**North Dakota State Implementation Plan  
for  
Regional Haze  
Amendment No. 1**

**A Plan for Implementing the Regional Haze Program Requirements  
of  
Section 308 of 40 CFR Part 51, Subpart P - Protection of Visibility**

Amendment No. 1  
to  
North Dakota State Implementation Plan  
For  
Regional Haze

**RESPONSES TO COMMENTS TO  
NDDH REGARDING REVISED DRAFT NO<sub>x</sub> BACT DETERMINATION and  
NORTH DAKOTA STATE IMPLEMENTATION PLAN for REGIONAL HAZE  
MILTON R. YOUNG STATION UNIT 1 and UNIT 2**

(by Cichanowicz, June 2007 - copied from Reference number 14, page 18, Figure 5.1)

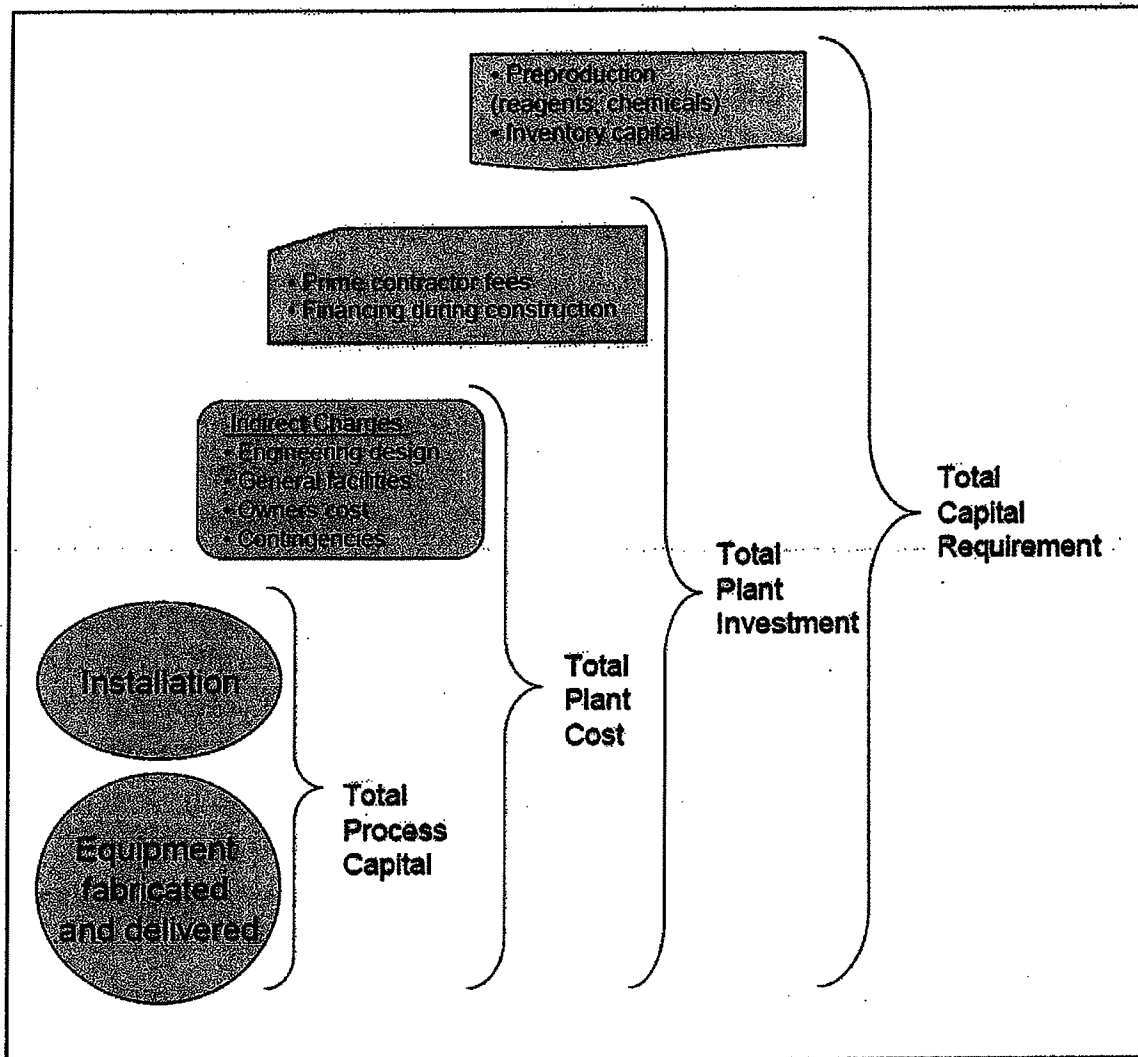
While we do not necessarily agree with the assumed percentages in the Cichanowicz paper as appropriate for Minnkota's non-typical hypothetical applications of low-dust and tail end SCR cases at this stage of project development, this methodology is illustrative of an alternate standard estimating approach. Also included in the indirect costs shown above is "Allowance for Funds During Construction (AFDC)" which the OAQPS Control Cost Manual for SCR assumed as zero<sup>31</sup> but Cichanowicz listed an assumption of 5-10% of Total Plant Cost (which is shown in Figure 5.1 copied herein). A significant portion of the Cichanowicz paper also discussed the rampant cost escalations incurred by many recent power plant emission control projects, involving both basic construction materials for shop and field-fabricated equipment, and construction labor.

Figure 7. Ash content of lignite fired at MRYS and future projected blend based on core database.

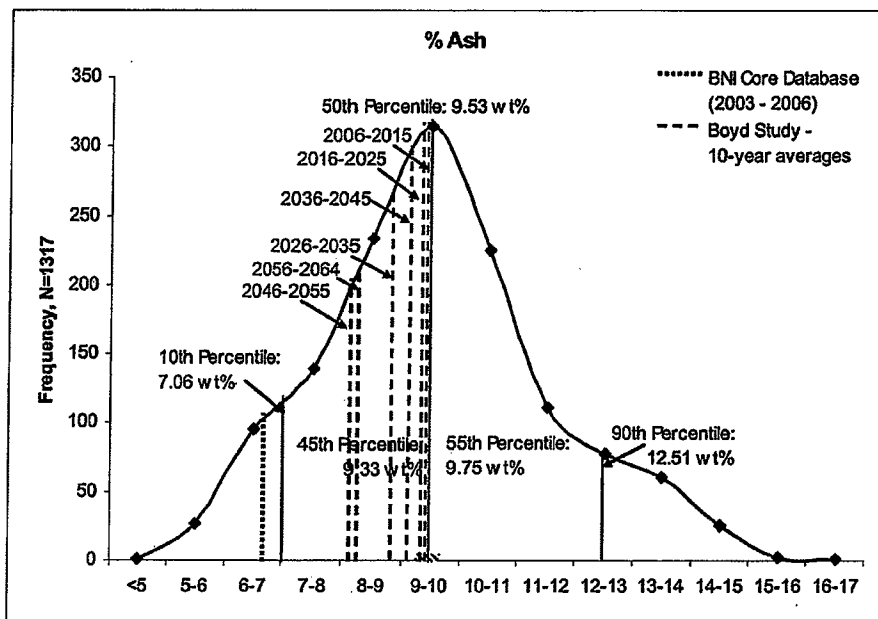
as-received basis as illustrated in Figure 7. North Dakota lignite coals having higher ash contents of between 12 and 19% were fired when much of the earlier testing was conducted by Markowski and others (1981). These higher ash lignites will produce lower levels of less than 1  $\mu\text{m}$  particulate as compared to the lower ash coal because of the abundance and form of the inorganic components in the North Dakota lignite described in detail in Appendix C of the report by Laumb and others (2009). For the high ash coals, Markowski and others (1983) measured the levels of particulate at the scrubber outlet to be 2500  $\mu\text{g}/\text{m}^3$ ; these coals are currently not fired without blending with lower ash coal to decrease the ash content because of challenges with cyclone performance. Fuel properties are managed to maintain an ash level and base-to-acid ratio that allows optimum performance of the cyclone fired combustion system. Relying on the particulate measurements made by Markowski and others (1983) on the high ash lignite as it appears that Hartenstein did in his 2010 SCR vendor inquiry does not represent the current and future fuels fired at the plant.

In addition, Hartenstein's comment "Appendix C [of the Microbeam report, July 2010] is merely a regurgitation of mostly irrelevant information"<sup>103</sup> indicates that he does not consider the forms and abundance of the inorganic components in North Dakota lignites as being important. This is a **major oversight of Hartenstein** in that the forms and abundance of the inorganic species in lignite have played a major role in the design as well as the feasibility of technologies that utilize North Dakota lignites. For example, the size of pulverized coal-fired boilers is much larger for high sodium lignite boilers than for subbituminous or bituminous fired systems. The larger size of the boiler allows for more cooling of the products of combustion to minimize fouling and slagging of the upper furnace waterwalls and convective pass superheater/reheater tubes. Further, pilot testing of Powerspan's barrier discharge reactor used for multipollutant technology at MRYS was found to be severely impacted by sodium aerosols.

**Figure 1: Comparison of Capital Costs Using Different Cost Methods**

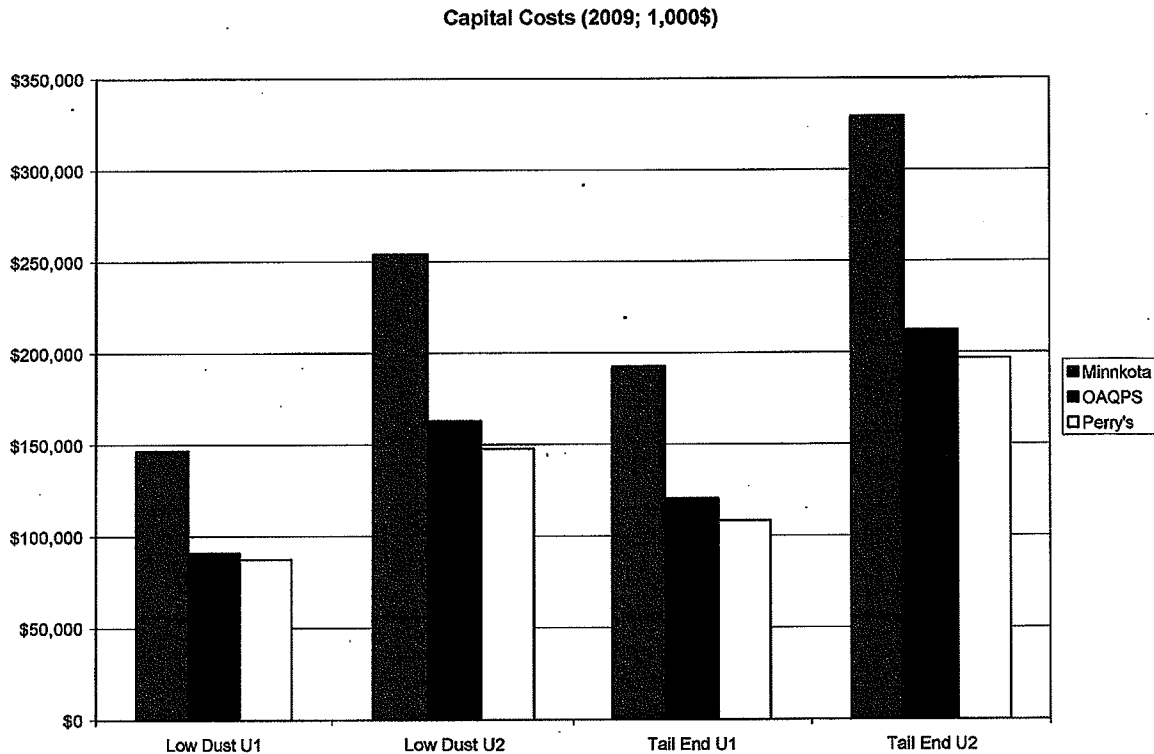
Because B&McD's cost factors are higher than both the Control Cost Manual and Perry's factors, EPA calculated two additional capital cost cases for comparison. Both cases used the same format as in B&McD's estimate, but used the Control Cost Manual and Perry's cost factors, where available. ERG used the 2009 B&McD's SCR costs which were back-calculated from the 2018 costs provided by Minnkota.<sup>44</sup> As can be seen from Table 4 and Figure 1, the capital costs estimated by B&McD for Minnkota are much higher than both the Control Cost Manual and Perry's. The Control Cost Manual and Perry's methods compare favorably.

**Figure 2: Comparison of Annual Costs Using Different Cost Methods**

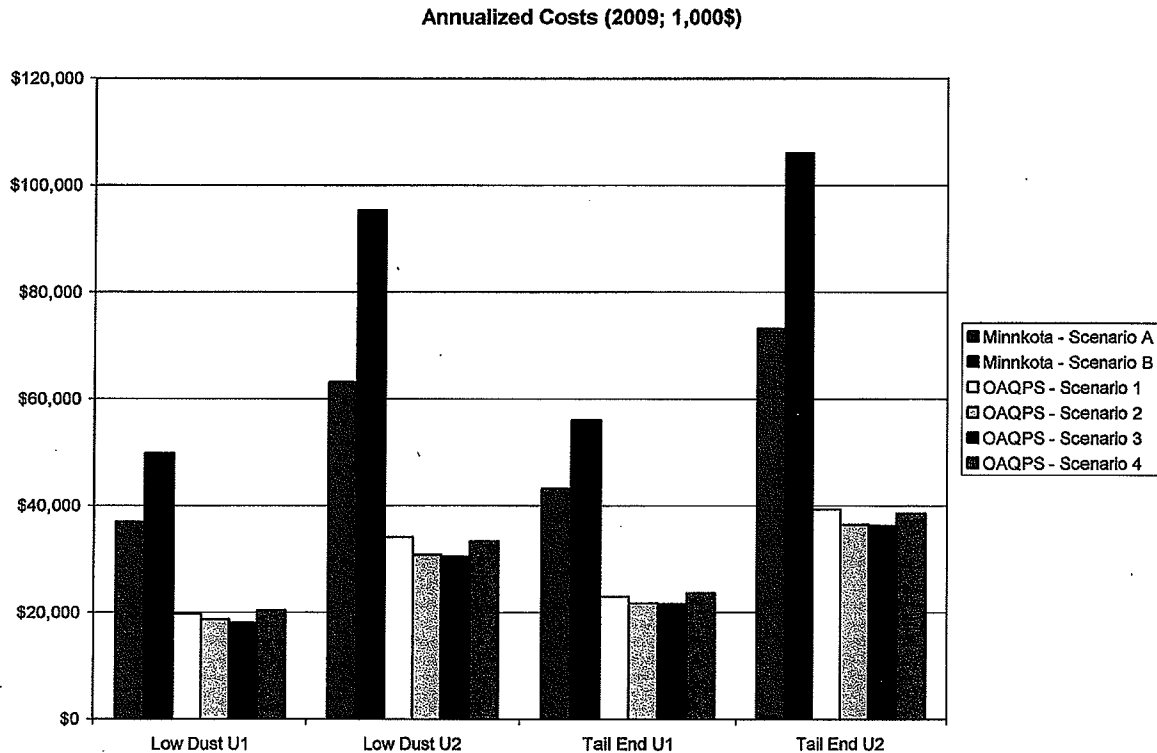
ERG used the above information and calculated annual costs. ERG calculated four different catalyst replacement scenarios. Scenarios 1 through 3 assume catalyst replacement of one layer per year, one layer every two years, and one layer every three years. EPA believes Scenario 3 is the most appropriate, as it reflects the performance guarantees provided by three catalyst vendors in response to Mr. Hartenstein’s RFP and the proposals provided to Minnkota by one vendor. No calculations were made for the “Scenario B” assumptions used by B&McD because, as EPA has stated previously and is well-documented in Mr. Hartenstein’s expert report, these assumptions are unsubstantiated and arbitrary. ERG’s Scenarios 1-3 do not include downtime for ASOFA because this has not been justified by Minnkota. Scenario 4 was run as the “worst-case” scenario and assumes all of the additional outage time is based on the additional outage times estimated for ASOFA provided by B&McD. There would be no additional unit outage time (and associated electricity costs) for catalyst replacement, because all of this work could be completed within the time allocated for ASOFA maintenance. As noted above, EPA does not necessarily concur that these additional outage times for ASOFA are legitimate and believes they should be justified by Minnkota. ERG modified the amount of time required for each catalyst layer replacement from B&McD’s assumptions, recalculated the unit availability using the revised downtime, and recalculated electricity costs and corresponding NO<sub>x</sub> emissions using the new availability. Table 5 shows the costs for each scenario. The annual costs in this table include the annual costs associated with capital recovery.

**Figure 2: Comparison of Cost-Effectiveness Using Different Cost Methods**

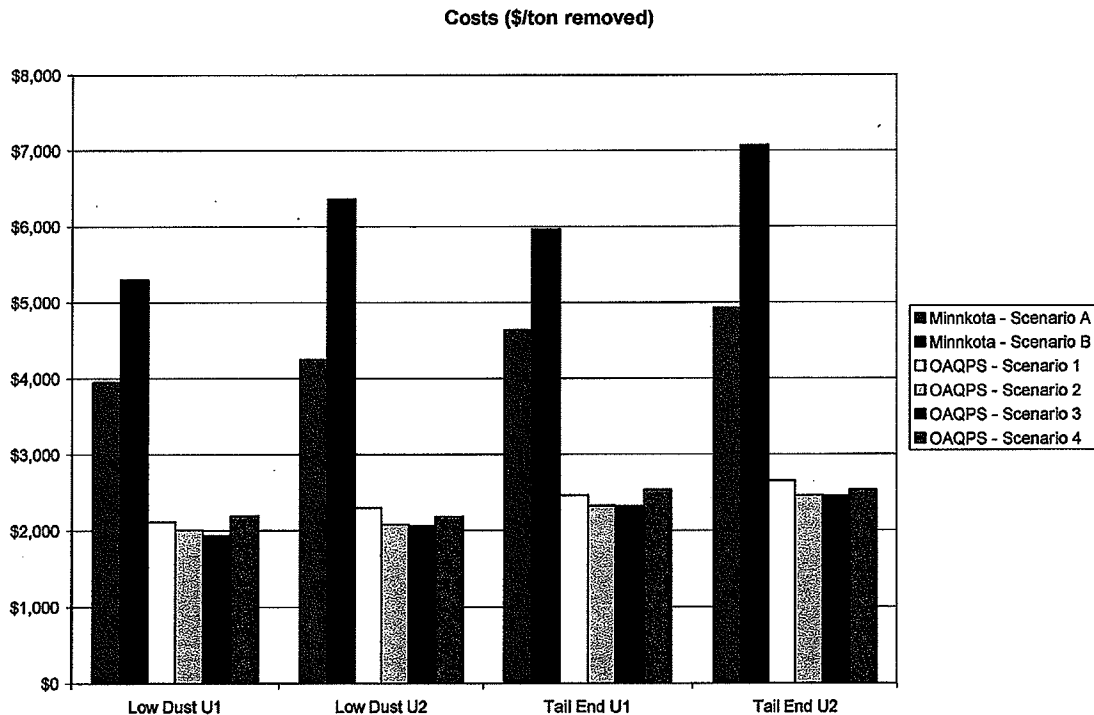
Table 6 shows the costs in dollars per ton of NO<sub>x</sub> removed in both 2009 and 2006 dollars. North Dakota averaged B&McD's Scenario A and B in their summary, which is also shown on the table. As can be seen from the table, when the Control Cost Manual cost factors are used in conjunction with baseline cost information provided by B&McD, supplemented with more reasonable cost data and assumptions on certain cost data, the cost-effectiveness is less than half of the "average" value of the two B&McD scenarios used by NDDH, even under the assumption that a layer of catalyst is replaced is every year (Control Cost Manual Scenario 1). This assumption is three times higher than the catalyst exchange rate that was provided in proposals from one catalyst vendor to Minnkota and performance guarantees provided to Mr. Hartenstein from three catalyst vendors. ERG's analysis is attached.<sup>45</sup>
